Service Alert

Subject: NEW DIFFERENTIALS DO NOT COME WITH BREATHER CAPS	Service Alert No.: SA-016/25
	Last Issued : 03/20/2025

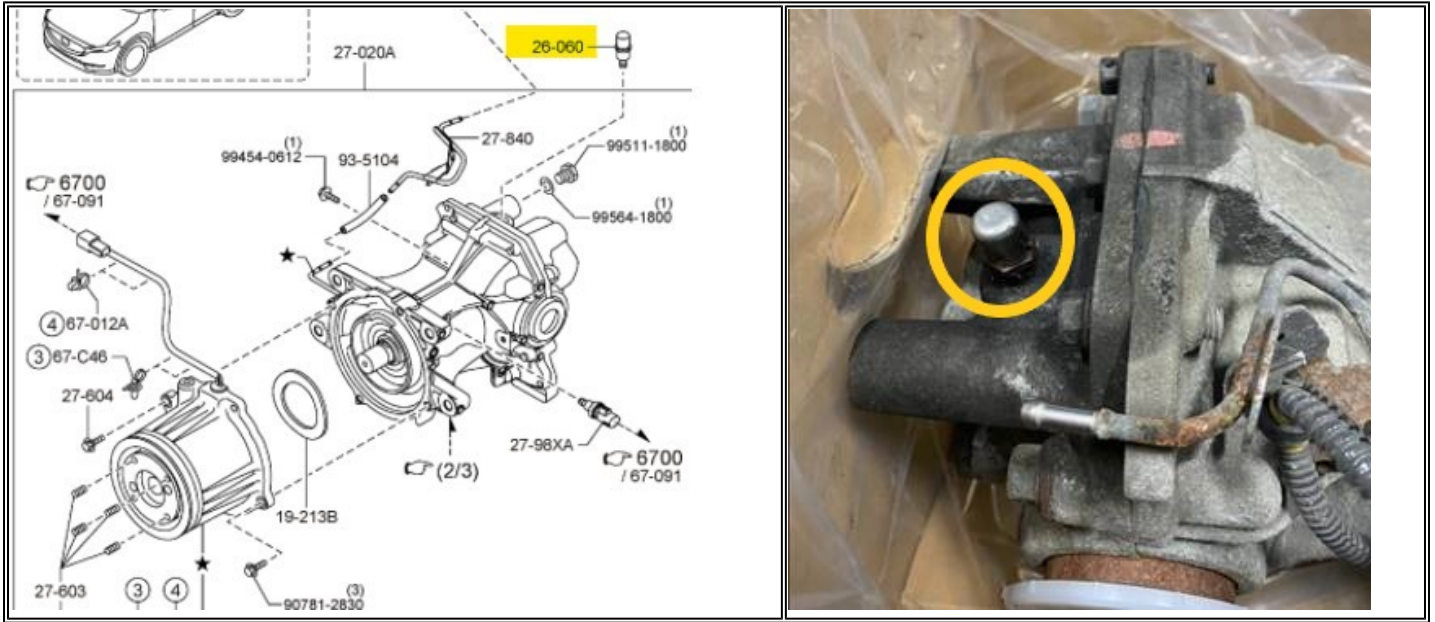
The new AWD rear differential DOES NOT come with a breather cap on the rear of the differential, therefore a new one will need to be ordered and installed when replacing the differential.

- The breather threads have a sealant and locking compound that prevents it from being reused.
- Refer to GEPC for the correct part number of the Differential Breather.
- The instructions on MGSS will be updated soon to include replacing the breather when replacing the differential with a new unit.
